Access Compliance Report Public Rights-of-Way (Curb Ramps)

Main Street: MOCHA_LN		Cross Street: LODEN_PASS		Location:	W
ADA ID: RPRK211201114821	Ramp Type: Type 4 - Parallel	Initial Pass/Fail: Fail	Overall Compliance: No	Severity Score:	2
Codes/Mitigation Info/Possible Solution			Field Measurements/Component Compliance

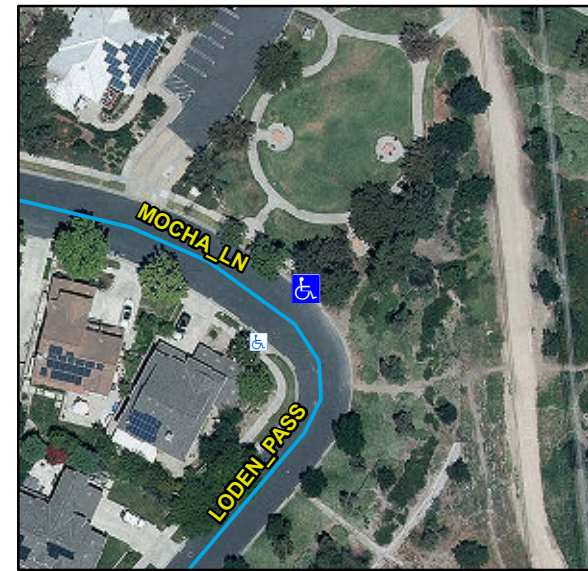
Compliance	Description	Data	Compliance	Description	Data
N/A	Ramp Length LT (in)	70	N/A	Ramp Length RT (in)	-9999
Yes	Ramp Width LT (in)	48	N/A	Ramp Width RT (in)	-9999
Yes	Ramp Run Slope LT (%)	3.3	N/A	Ramp Run Slope RT (%)	-9999
No	Ramp Cross Slope LT (%)	3.2	N/A	Ramp Cross Slope RT (%)	-9999
N/A	Landing Present	N/A	N/A	DWS Provided	N/A
N/A	Landing Length (in)	N/A	N/A	DWS Contrast	N/A
N/A	Landing Width (in)	N/A	N/A	DWS Length (in)	N/A
N/A	Landing Run Slope (%)	N/A	N/A	DWS Full Width	N/A
N/A	Landing Cross Slope (%)	N/A		DWS Offset Type	N/A
N/A	Landing Movement Obstructed?	N/A	N/A	DWS Offset Left (in)	N/A
	Landing Movement Type	N/A	N/A	DWS Offset Right (in)	N/A
N/A	Landing Shared	N/A			
N/A	Clear Space	N/A			
N/A	Clear Space To Crosswalk (in)	N/A			
N/A	Marked Crosswalk 1	No	N/A	Marked Crosswalk 2	N/A
	Crossing 1 Direction	S		Crossing 2 Direction	N/A
	Marked Crosswalk 1 Width (in)	N/A		Marked Crosswalk 2 Width (in)	N/A

Remove & Replace Entire Ramp.
